UNITED STATES PATENT AND TRADEMARK OFFICE

APPLICATION NO.	FILING DATE	FIRST NAMED INVENTOR	ATTORNEY DOCKET NO.	CONFIRMATION NO.
09/579,466	05/26/2000	Koichi Sato	P19105	7486
7055	7590	08/09/2004	EXAMINER	
GREENBLUM & BERNSTEIN, P.L.C. 1950 ROLAND CLARKE PLACE RESTON, VA 20191			GENCO, BRIAN C	
			ART UNIT	PAPER NUMBER
			2615	
DATE MAILED: 08/09/2004

Office Action Summary

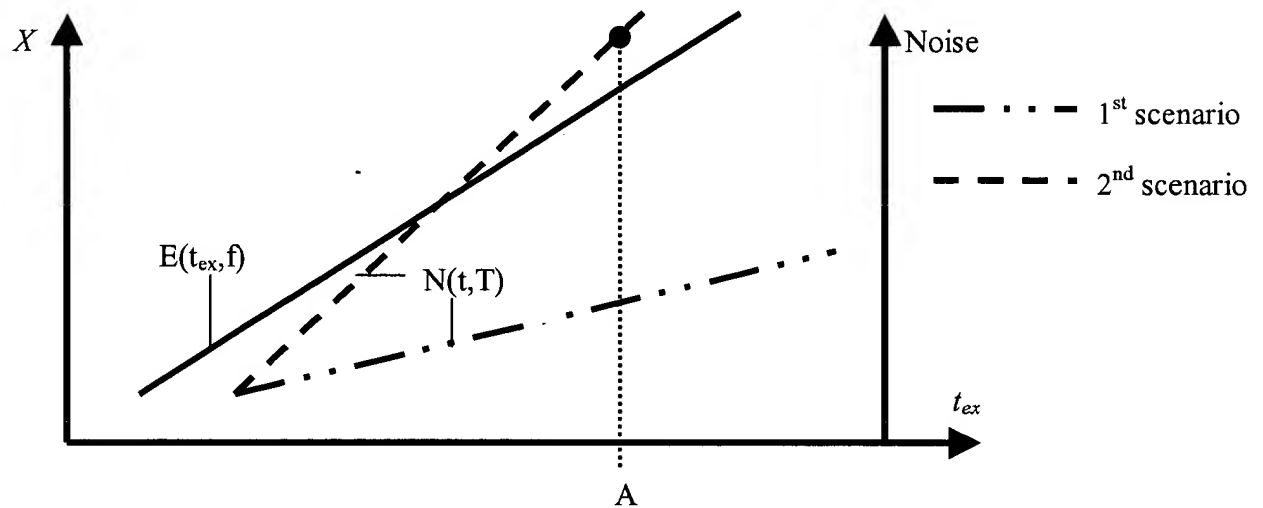
Examiner notes that AAPA discloses on page 2, lines 6-14 that as the temperature increases, the amount of noise increases and further that as the accumulating period increases, the amount of noise increases. Examiner concedes that no further details are given as to the rate of increase in noise as exposure time increases, however, one skilled in the art would clearly recognize that two scenario's are possible as illustrated bellow.

Examiner notes that in the above illustration the solid line represents X as a function of the exposure time as disclosed by Hynecek in equation 8. Examiner notes that this line has a slope of $f_g \cdot dN_{bp} / dN_{abp}$ for a given gate clocking frequency. The rate of increase in noise generated by having a longer exposure period as disclosed by AAPA is illustrated by the two dashed lines above with respect to the noise axis. In the first scenario, the rate of increase in noise as the exposure period increases is less than or equal to $f_g \cdot dN_{bp} / dN_{abp}$, in which case the current gate clocking frequency is sufficient to eliminate the noise. However, in the second scenario, the rate of increase in noise as the exposure period increases is greater than $f_g \cdot dN_{bp} / dN_{abp}$. In this case, Examiner notes that the only other variable that can be changed is the gate clocking frequency. As such, when the line of

the second scenario crosses the line of X , the gate clocking frequency must be increased so as to handle the increased noise as would clearly be recognized by one skilled in the art. In other words, in the second scenario, given the exposure time for a current frame is set to A as illustrated above, the amount of noise generated is greater than the amount of noise that can be eliminated. In looking at Hynecek's equation given a fixed exposure time A for a current frame, noise increases, or the amount of noise needed to be eliminated, X , is increased. The only variable that can be adjusted to compensate for this increased noise is the gate clocking frequency. Examiner notes that it is extremely well known to calculate an exposure period for a current frame in order to enable proper exposure as is taught by Tani.
